# TOWNSHIP OF BRICK

March 20, 2019

RE: BA-3132-PSP-FSP-D-12/18  
Vilamoura, LLC  
Block 69, Lots 8 & 8.01  
29-39 Mantoloking Road  
Preliminary & Final Site Plan  
W/Variance ~First Review

Site Aerial Photographs:

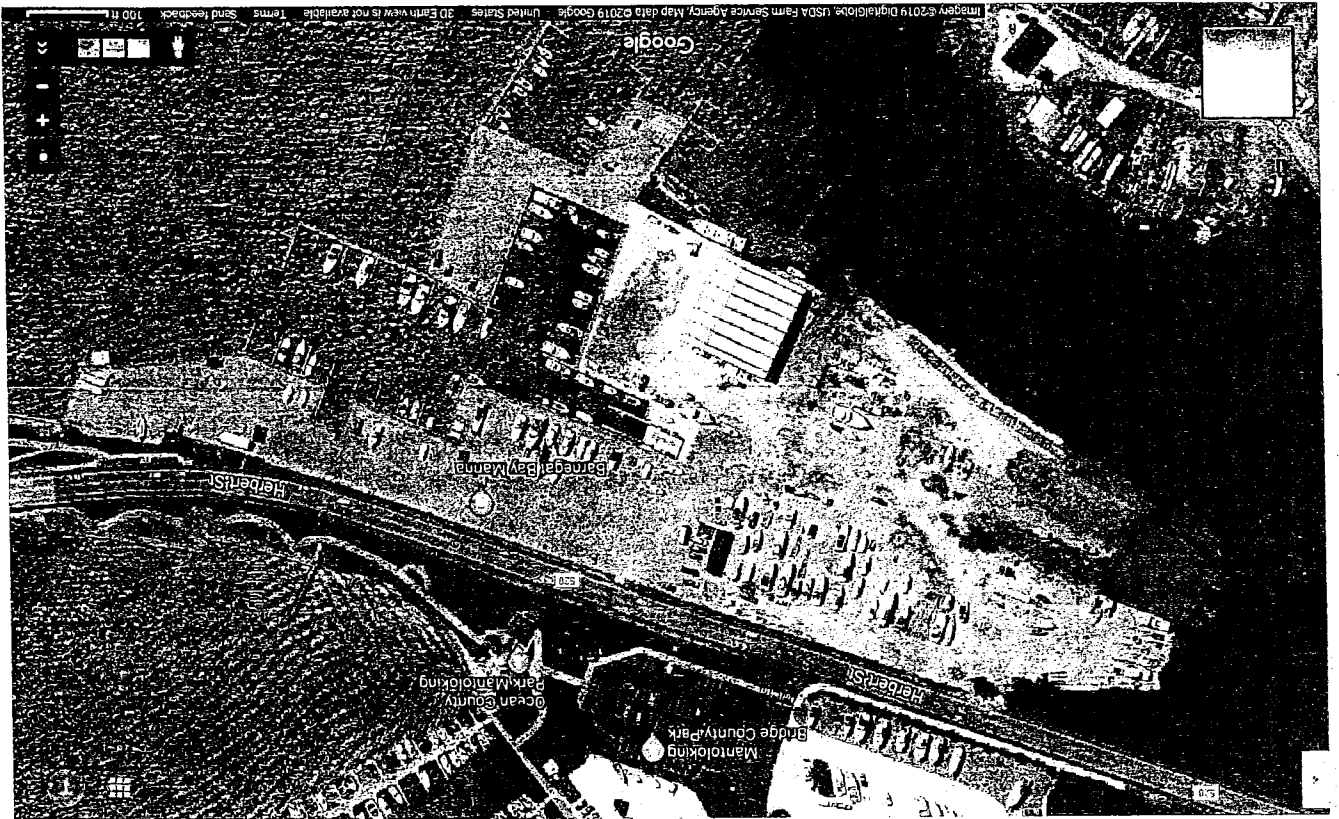
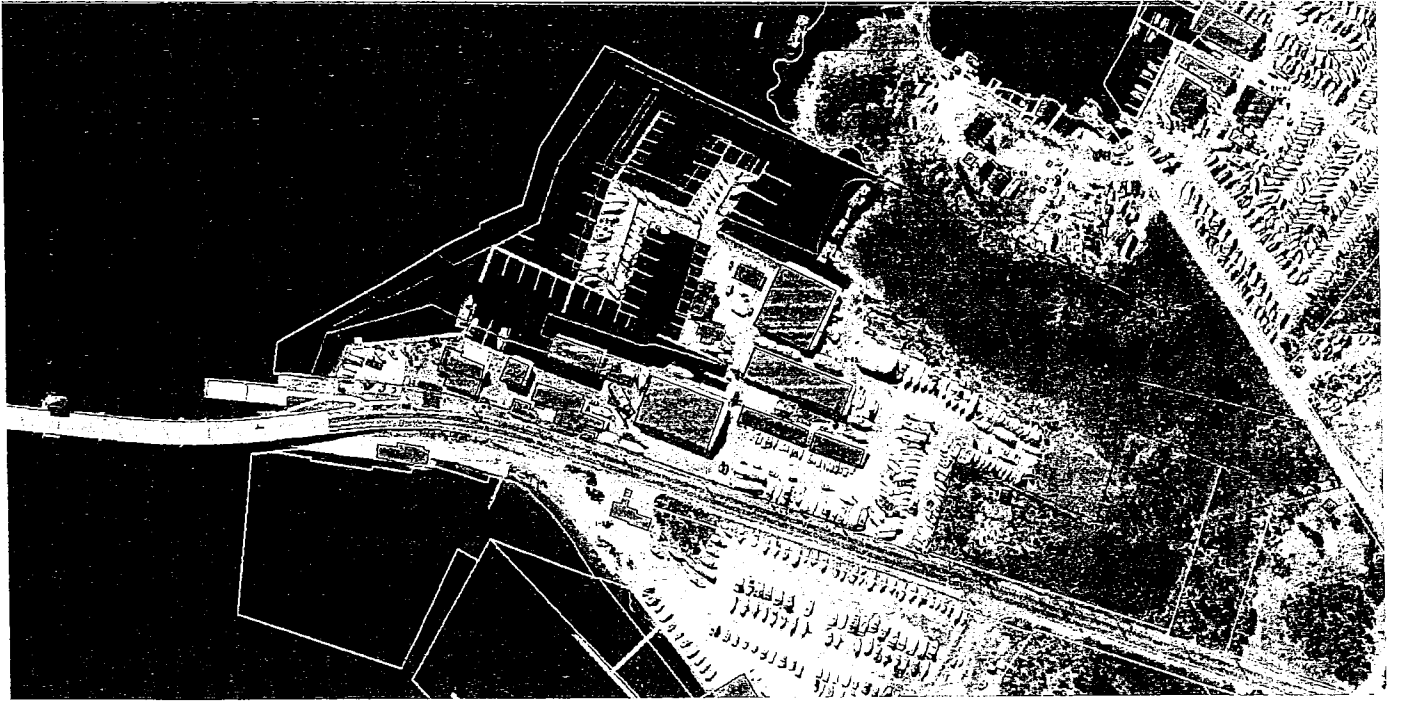
- A. A site visit was conducted on 3/21/19 and the site was found to be in good condition. The site was tidy and neat, well maintained and in good operation.

- D. The site was observed to house dozens and dozens of boats in upland storage. Please indicate how many boats are currently housed in upland storage and how the impact of the development of the site for the restaurant and banquet facility will be accomplished. It appears the current number of boats stored upland will not be able to be accommodated after the facilities and parking lot are constructed. Will they be stored off site?
